Central Gardens EXTERIOR

Assembly	Exterior Access Route
Type	Exterior Accessible Route
ADA Standard	303

Barrier Detail

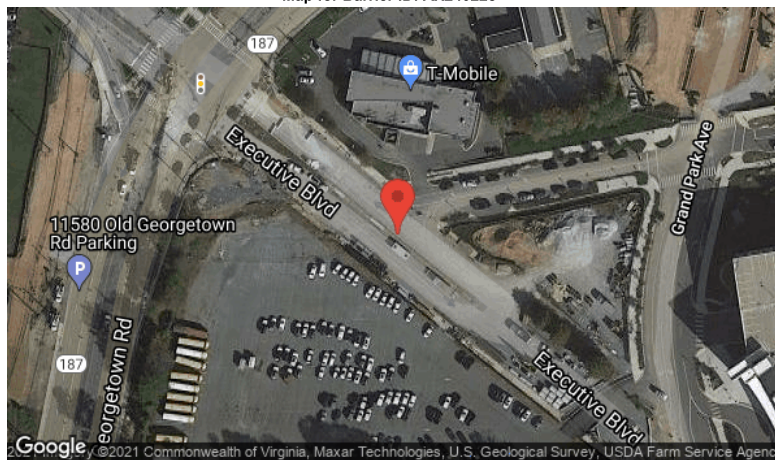
Assembly	Exterior Access Route
Type	Ramp
ADA Standard	405.8 and 505
Barrier Detail	The ramp run has a rise greater than 6"; however, handrails are not provided.
Location Description	To Building 6812 Entrance
Observed	May 28, 2021 by Lloyd.fojas@bureauveritas.com

The accessible route has a set of stairs with 5 risers and a 7-1/2" vertical change at the door. A ramp with a rise of 45", a bottom landing and 1 intermediate landing is needed. The new ramp will need handrails.

Provide compliant handrails or provide ramp runs with maximum 6" rise. Handrails are required on ramp runs which rise more than 6". Replace with continuous handrails at a consistent height above the ramp on both sides of the ramp. Inside handrails on switchback or dogleg stairs and ramps shall be continuous between runs. Top of gripping surfaces of handrails shall be 34" minimum and 38" maximum vertically above ramp surfaces. Handrails shall be at a consistent height above ramp surfaces. Clearance between handrail gripping surfaces and adjacent surfaces shall be 1-1/2" minimum. Handrail gripping surfaces shall be continuous along their length and shall not be obstructed along their tops or sides. The bottoms of handrail gripping surfaces shall not be obstructed for more than 20% of their length. Where provided, horizontal projections shall occur 1-1/2" minimum below the bottom of the handrail gripping surface. [EXCEPTIONS: 1. Where handrails are provided along walking surfaces with slopes not steeper than 1:20, the bottoms of handrail gripping surfaces shall be permitted to be obstructed along their entire length where they are integral to crash rails or bumper guards. 2. The distance between horizontal projections and the bottom of the gripping surface shall be permitted to be reduced by 1/8" for each 1/2" of additional handrail perimeter dimension that exceeds 4".] Handrail gripping surfaces with a circular cross section shall have an outside diameter of 1-1/4" minimum and 2" maximum. Handrail gripping surfaces with a non-circular cross section shall have a perimeter dimension of 4" minimum and 6-1/4" maximum, and a cross-section dimension of 2-1/4" maximum. Handrail gripping surfaces and any surfaces adjacent to them shall be free of sharp or abrasive elements and shall have rounded edges. Handrails shall not rotate within their fittings. Handrail gripping surfaces shall extend beyond and in the same direction of ramp runs. [EXCEPTIONS: 1. Extensions shall not be required for continuous handrails at the inside turn of switchback or dogleg ramps AND 3. In alterations, full extensions of handrails shall not be required where such extensions would be hazardous due to plan configuration.] Ramp handrails shall extend horizontally above the landing for 12" minimum beyond the top and bottom of ramp runs. Extensions shall return to a wall, guard, or the landing surface, or shall be continuous to the handrail of an adjacent ramp run.

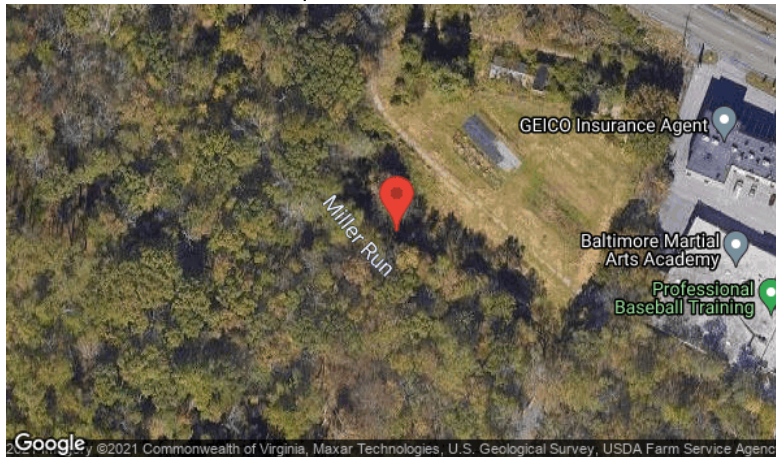
Assembly	Exterior Access Route
Type	Ramp
ADA Standard	405.8 and 505
Barrier Detail	The ramp run has a rise greater than 6"; however, handrails are not provided.
Location Description	To Pool House Entrance
Observed	May 28, 2021 by Lloyd.fojas@bureauveritas.com

The accessible route has a 6.1% running slope and a 9" vertical change. Based on the slope on the 12' long accessible route and the vertical change a ramp with a rise of 18" is needed for access. The new ramp will need handrails.

Provide compliant handrails or provide ramp runs with maximum 6" rise. Handrails are required on ramp runs which rise more than 6". Replace with continuous handrails at a consistent height above the ramp on both sides of the ramp. Inside handrails on switchback or dogleg stairs and ramps shall be continuous between runs. Top of gripping surfaces of handrails shall be 34" minimum and 38" maximum vertically above ramp surfaces. Handrails shall be at a consistent height above ramp surfaces. Clearance between handrail gripping surfaces and adjacent surfaces shall be 1-1/2" minimum. Handrail gripping surfaces shall be continuous along their length and shall not be obstructed along their tops or sides. The bottoms of handrail gripping surfaces shall not be obstructed for more than 20% of their length. Where provided, horizontal projections shall occur 1-1/2" minimum below the bottom of the handrail gripping surface. [EXCEPTIONS: 1. Where handrails are provided along walking surfaces with slopes not steeper than 1:20, the bottoms of handrail gripping surfaces shall be permitted to be obstructed along their entire length where they are integral to crash rails or bumper guards. 2. The distance between horizontal projections and the bottom of the gripping surface shall be permitted to be reduced by 1/8" for each 1/2" of additional handrail perimeter dimension that exceeds 4".] Handrail gripping surfaces with a circular cross section shall have an outside diameter of 1-1/4" minimum and 2" maximum. Handrail gripping surfaces with a non-circular cross section shall have a perimeter dimension of 4" minimum and 6-1/4" maximum, and a cross-section dimension of 2-1/4" maximum. Handrail gripping surfaces and any surfaces adjacent to them shall be free of sharp or abrasive elements and shall have rounded edges. Handrails shall not rotate within their fittings. Handrail gripping surfaces shall extend beyond and in the same direction of ramp runs. [EXCEPTIONS: 1. Extensions shall not be required for continuous handrails at the inside turn of switchback or dogleg ramps AND 3. In alterations, full extensions of handrails shall not be required where such extensions would be hazardous due to plan configuration.] Ramp handrails shall extend horizontally above the landing for 12" minimum beyond the top and bottom of ramp runs. Extensions shall return to a wall, guard, or the landing surface, or shall be continuous to the handrail of an adjacent ramp run.

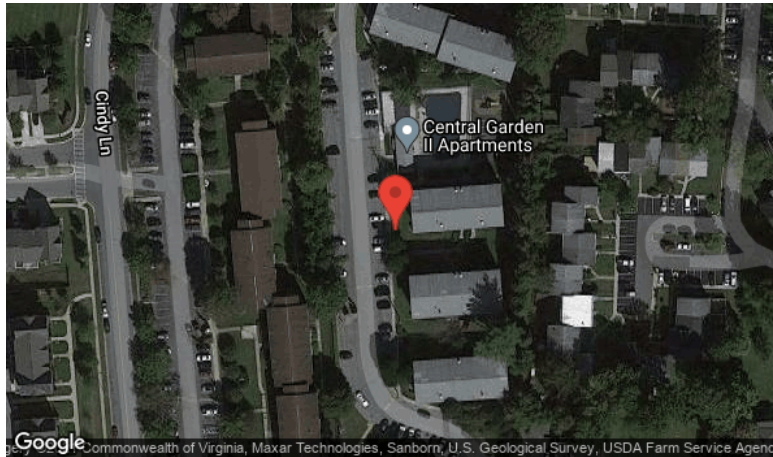
Assembly	Exterior Access Route
Type	Gate
ADA Standard	404.2.10
Barrier Detail	The gate does not have a smooth surface within 10" of the ground.
Location Description	Gate at Adult's and Children's Pools
Observed	May 28, 2021 by Lloyd.fojas@bureauveritas.com

Provide a swinging gate with a smooth surface within 10" of the ground, measured vertically on the push side of the gate and extending the full width of the gate. Parts creating horizontal or vertical joints in the surfaces shall be within 1/16" of the same plane as the other. Cavities created by adding kick plates shall be capped.

Photos for Barrier ID: AX239645

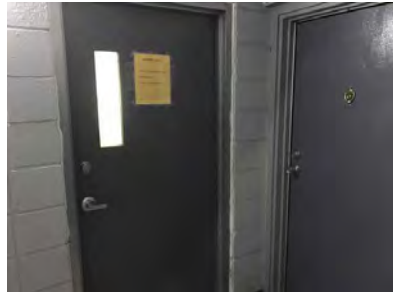
Assembly	Common Areas
Type	Door
ADA Standard	UFAS 4.13.6; Fig. 25
Barrier Detail	The door does not have compliant maneuvering clearances.
Location Description	Laundry Room in Building 6806 and 6810
Observed	May 28, 2021 by Lloyd.fojas@bureauveritas.com
Site Conditions	For a front approach on the pull side the side clearance is 10 1/2".

Compliant level and clear maneuvering clearances should be installed at accessible doors. Minimum maneuvering clearances at doors that are not automatic or power-assisted shall be as shown in Fig. 25. The required depth of the maneuvering clearance is 60" minimum. The required side clearance is 18" minimum on the latch side of the door. Maneuvering clearance shall extend the full width of the doorway and the required latch side clearance. Floor or ground space within the required maneuvering clearance shall be maximum 1:50 (2%) slope. The floor or ground area within the required clearances shall be level and clear. Entry doors to acute care hospital bedrooms for in-patients shall be exempted from the requirement for space at the latch side of the door (see dimension "x" in Fig. 25) if the door is at least 44" wide.

Photos for Barrier ID: AX239660

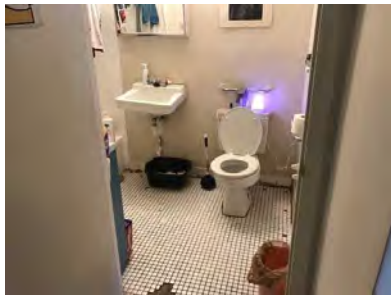
Assembly	Residential Dwelling
Type	Door
ADA Standard	UFAS 4.13.8
Barrier Detail	The threshold at the accessible door is greater than 1/2" in height.
Location Description	Bathroom in Unit 6810-101
Observed	May 28, 2021 by Lloyd.fojas@bureauveritas.com
Site Conditions	The threshold is 1-1/4" tall.

Remove and replace with a threshold that is 1/2" or less in height. Thresholds at doorways shall not exceed 1/2", except for exterior sliding doors which shall not exceed 3/4" in height. Raised thresholds and floor level changes at accessible doorways shall be beveled with a slope not greater than 1:2. Doors to and in accessible spaces that are intended for passage shall comply,

Photos for Barrier ID: AX240071

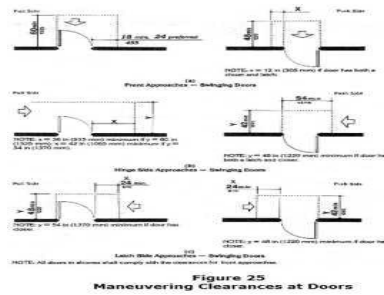
Assembly	Interior Access Route
Type	Door
ADA Standard	UFAS 4.13.6; Fig. 25
Barrier Detail	The accessible door does not have the required maneuvering clearances.

For a front approach on the pull side the maneuvering clearance has a vertical change of 1-3/4" directly at the threshold.

Replace with a compliant maneuvering clearance area that is level and clear. Minimum maneuvering clearances at doors that are not automatic or power-assisted shall be as shown in Figure 25. The required depth of the maneuvering clearance is 60" minimum. The required side clearance is 18" minimum on the latch side of the door. Maneuvering clearance shall extend the full width of the doorway and the required latch side clearance. The floor or ground area within the required clearances shall be level and clear. Entry doors to acute care hospital bedrooms for in-patients shall be exempted from the requirement for space at the latch side of the door (see dimension 'x' in Figure 25), if the door is at least 44" wide.

Photos for Barrier ID: AX239594

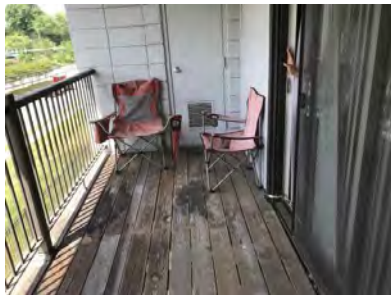
Assembly	Entrance to Building
Type	Building Entrance-Door
ADA Standard	UFAS 4.13.6; Fig. 25
Barrier Detail	The maneuvering clearance area at the accessible door is not level and clear.

Remove and replace with a compliant maneuvering clearance area that is level and clear. Minimum maneuvering clearances at doors that are not automatic or power-assisted shall be as shown in Figure 25. The required depth of the maneuvering clearance is 48" minimum. The required side clearance is 0" minimum on the latch side of the door. Maneuvering clearance shall extend the full width of the doorway and the required latch side clearance. The floor or ground area within the required clearances shall be level and clear. Entry doors to acute care hospital bedrooms for in-patients shall be exempted from the requirement for space at the latch side of the door (see dimension 'x' in Figure 25), if the door is at least 44" wide.

Photos for Barrier ID: AX239662

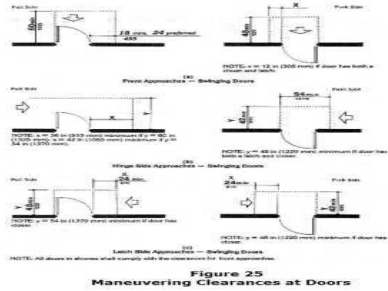
Assembly	Entrance to Building
Type	Building Entrance-Door
ADA Standard	UFAS 4.13.6; Fig. 25
Barrier Detail	The maneuvering clearance area at the accessible door is not level and clear.
Location Description	Patio Entrance at Unit 6810-102
Observed	May 28, 2021 by Lloyd.fojas@bureauveritas.com

Remove and replace with a compliant maneuvering clearance area that is level and clear. Minimum maneuvering clearances at doors that are not automatic or power-assisted shall be as shown in Figure 25. The required depth of the maneuvering clearance is 48" minimum. The required side clearance is 0" minimum on the latch side of the door. Maneuvering clearance shall extend the full width of the doorway and the required latch side clearance. The floor or ground area within the required clearances shall be level and clear. Entry doors to acute care hospital bedrooms for in-patients shall be exempted from the requirement for space at the latch side of the door (see dimension 'x' in Figure 25), if the door is at least 44" wide.

Photos for Barrier ID: AX239656

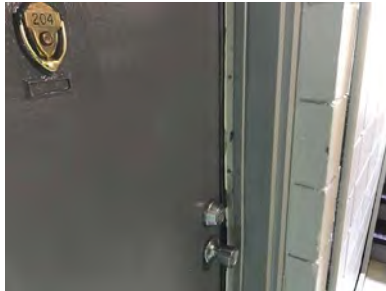
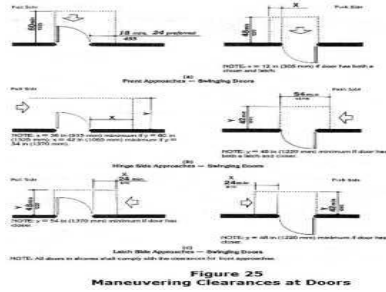
Assembly	Entrance to Building
Type	Building Entrance-Door
ADA Standard	UFAS 4.13.6; Fig. 25
Barrier Detail	The maneuvering clearance area at the accessible door is not level and clear.
Location Description	Patio Entrance at Unit 6810-204
Observed	May 28, 2021 by Lloyd.fojas@bureauveritas.com

Remove and replace with a compliant maneuvering clearance area that is level and clear. Minimum maneuvering clearances at doors that are not automatic or power-assisted shall be as shown in Figure 25. The required depth of the maneuvering clearance is 48" minimum. The required side clearance is 0" minimum on the latch side of the door. Maneuvering clearance shall extend the full width of the doorway and the required latch side clearance. The floor or ground area within the required clearances shall be level and clear. Entry doors to acute care hospital bedrooms for in-patients shall be exempted from the requirement for space at the latch side of the door (see dimension 'x' in Figure 25), if the door is at least 44" wide.

Photos for Barrier ID: AX239577

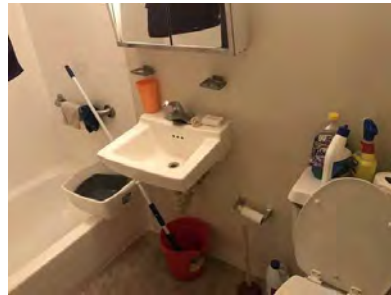
Assembly	Residential Dwelling
Type	Restroom/Bathroom-Lavatory
ADA Standard	UFAS 4.19.4
Barrier Detail	Lavatory hot water and drain pipes are not insulated.
Location Description	Bathroom in unit 6812-102
Observed	May 28, 2021 by Lloyd.fojas@bureauveritas.com
Site Conditions	The lavatory drain pipes and water supply lines are not insulated.

Insulate hot water and drain pipes under the accessible lavatory. Hot water and drain pipes under lavatories shall be insulated or otherwise covered. There shall be no sharp or abrasive surfaces under lavatories.
